SERVICE NO. 1355A BULLETIN

Date: March 14, 2022

TEE BAR ASSEMBLY INSPECTION

SB 1355A clarifies instructions and corrects a reference error

Figure 1
Tee Bar Assembly – Weldment

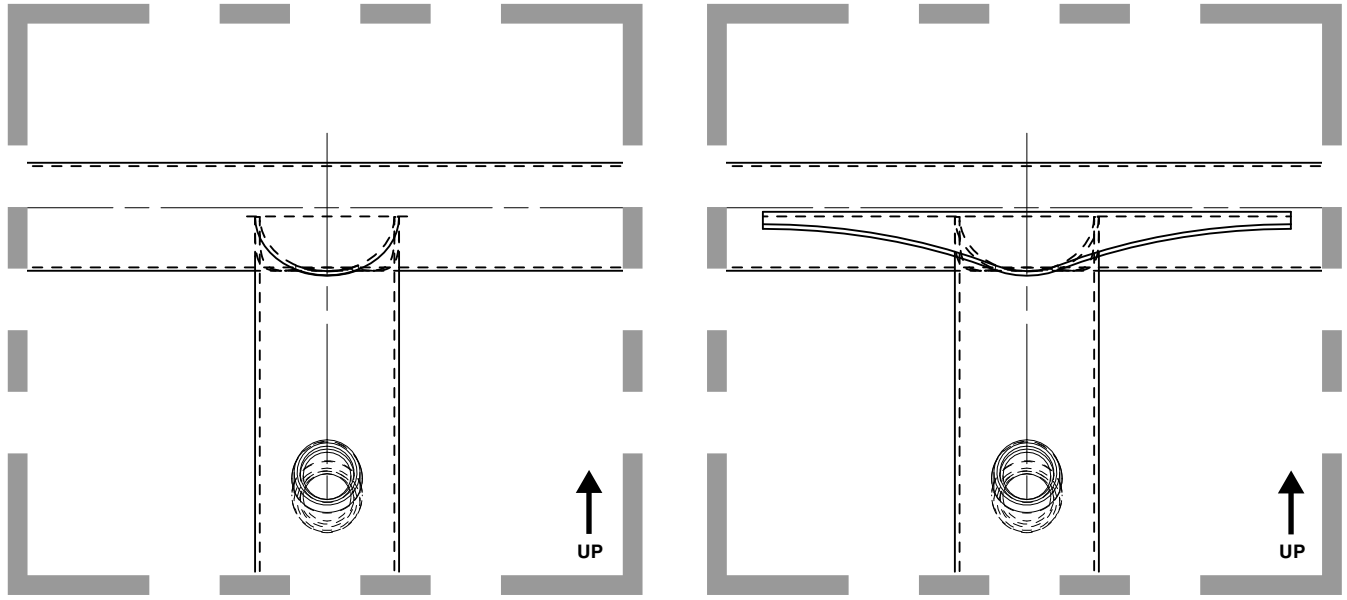
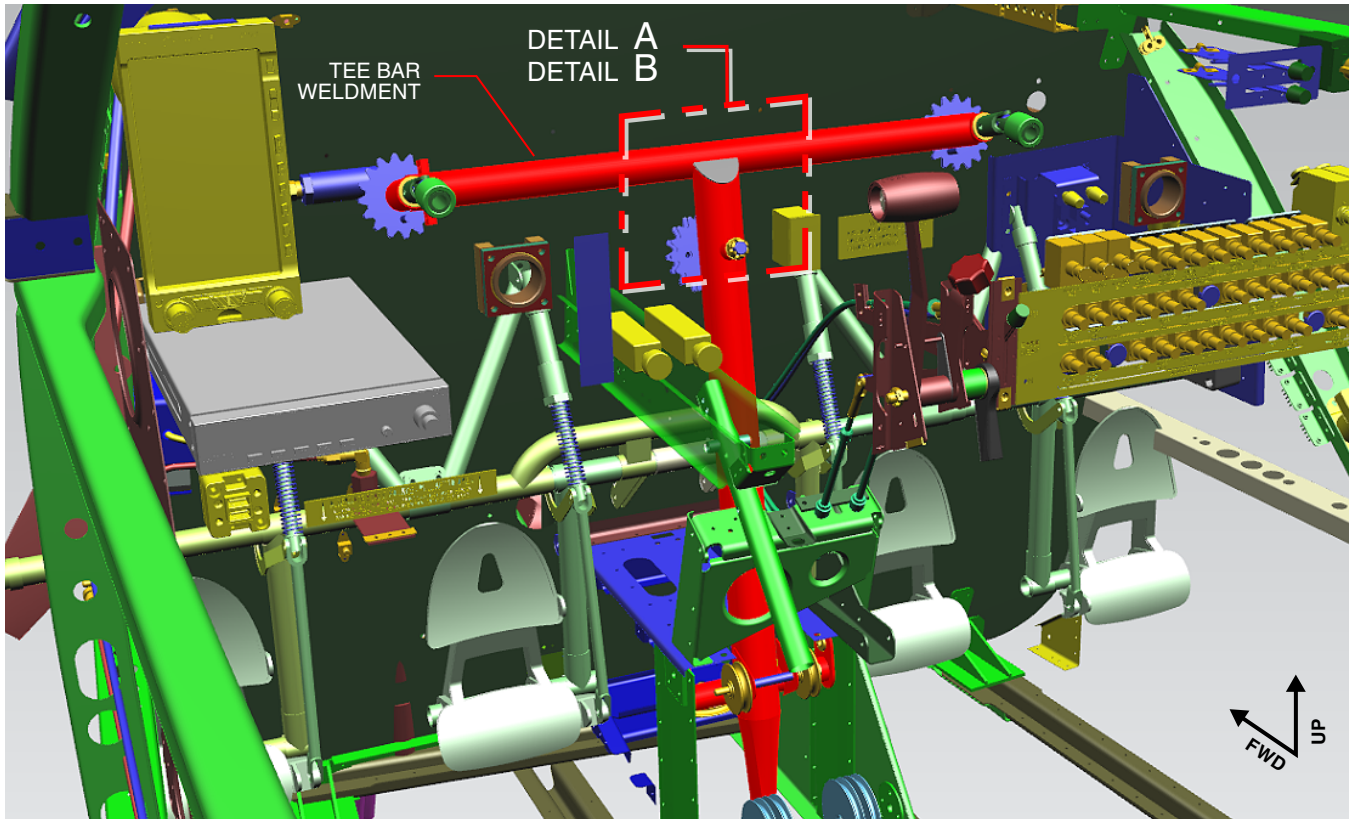
NOTE: Modification of the tee bar assembly as described in Part II, or installation of a replacement tee bar assembly with the features shown in Figure 1, Detail B, will relieve the recurring inspection requirement in Part I.

1. Gain visual access to the top center portion of the tee bar assembly, as shown in Figure 1. Identify the configuration of the tee bar weldment assembly.
 - If the local area conforms to Figure 1, Detail A, then recurring inspections are required. Proceed to Step 2.
 - If the local area conforms to Figure 1, Detail B, then the factory original tee bar assembly has already been replaced with a tee bar assembly containing the required features (i.e., gusset) and is already in compliance with Part II. Therefore, no recurring inspections are required. Proceed to Part II, Step 8.

2. Examine the area shown in Detail A for cracks, with special emphasis on welded joints.

- b. Perform a fluorescent dye penetrant inspection per FAA Advisory Circular AC 43.13-1B, Chapter 5, Section 5.
 - If any cracks are discovered, then the tee bar weldment must be replaced prior to next flight. Proceed to Part II.
 - If no cracks are discovered, apply primer and topcoat to bare metal, per the applicable Piper Airplane Maintenance Manual (AMM) or Service Manual (SM) and FAA Advisory Circular AC 43.13-1B, Chapter 6. Proceed to Step 3.

Figure 2

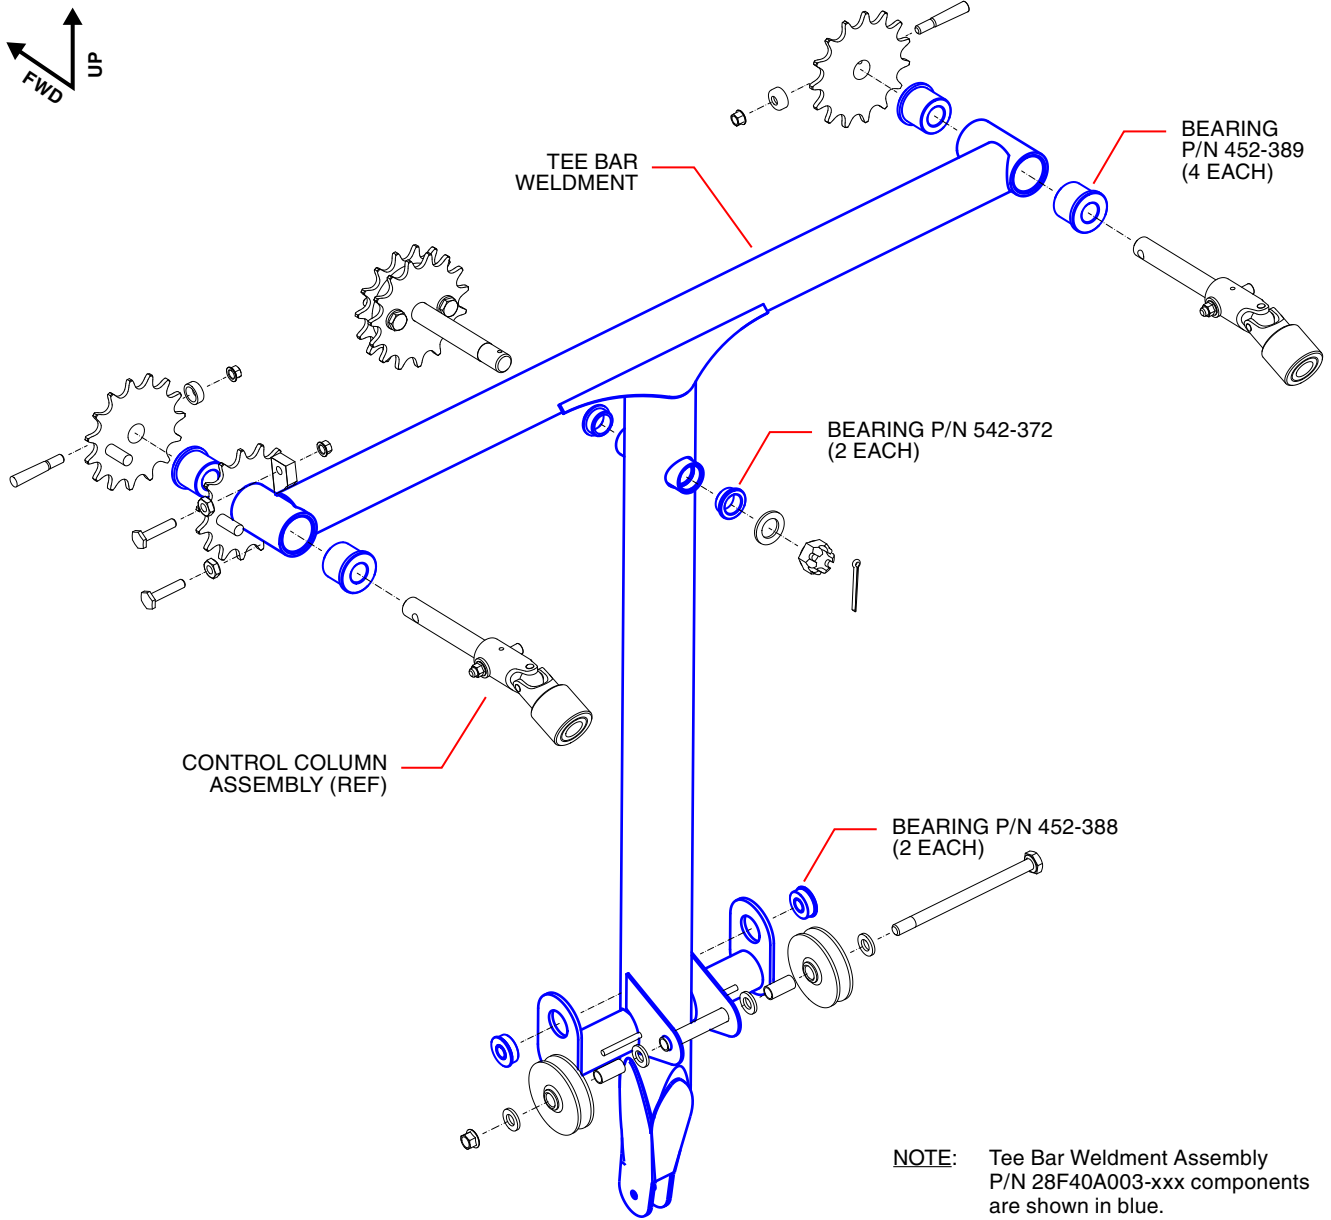
4. Assemble the control wheel tee bar assembly (refer to Figure 2): Install the sprockets, control wheel columns, and hardware, which were removed from the original weldment assembly in the previous step, onto the replacement tee bar weldment assembly.

Figure 3
Brass Shim P/N 62833-152 Installation Location

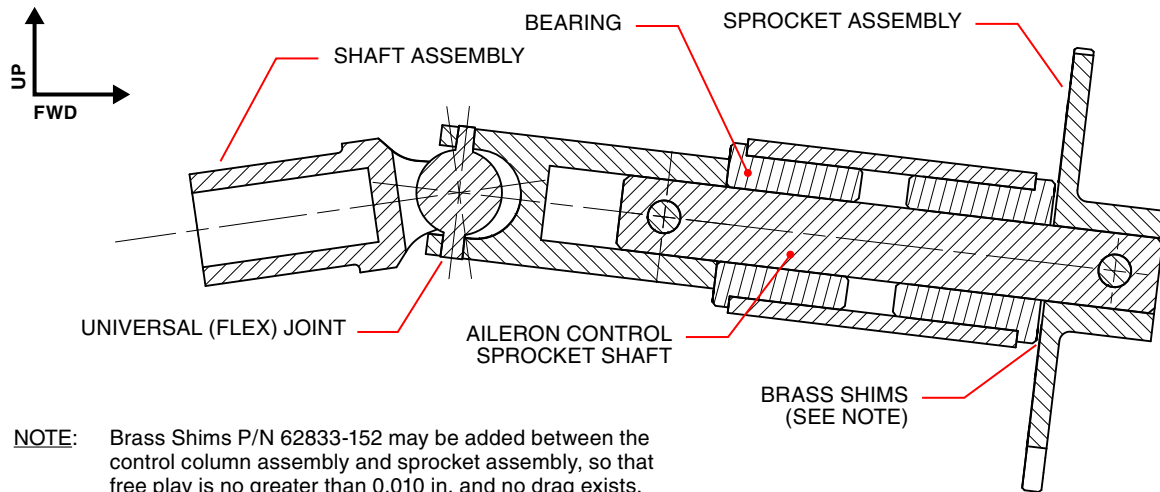
5. Reinstall the control column tee bar assembly and control wheel columns, in accordance with Section 27-10-00 of the applicable Piper AMM or Section V of the applicable SM. If necessary, so that there is no greater than 0.010 in. of free play (relative motion) and no drag exists between the control columns and sprocket assemblies, add Brass Shims, Piper P/N 62833-152, no more than two (2) per side, as shown in Figure 3.
